Battery Charger Replacement Kit

Model: S8 Sweeper

NOTICE: The below battery chargers have been discontinued and replaced by this new battery charger kit. Use existing hardware to mount new charger to machine as shown below. The new battery charger is factory set to charge a sealed (Gel) battery. To charge a Wet (lead acid) battery, set the DIP switch positions as described below.

Discontinued Battery Chargers

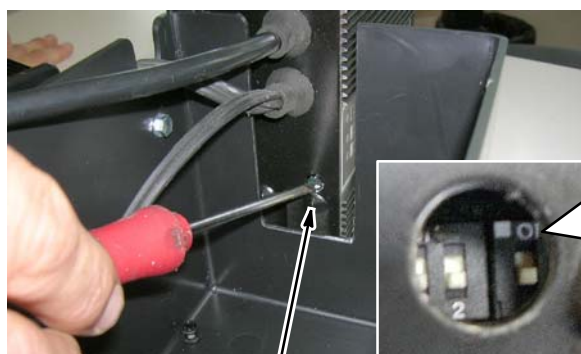
p/n 9001455-EU, 9001456-US,
9001457-JP, 9001458-UK

New Battery Charger Kit

p/n 1064876

Use existing hardware to mount new charger.

Charger DIP Switch Settings

Select the appropriate DIP Switch setting before attaching charger to machine. Remove the round black cap to access DIP switches.

WET (Lead Acid) Battery

Sealed (GEL) Battery

(Factory Setting)
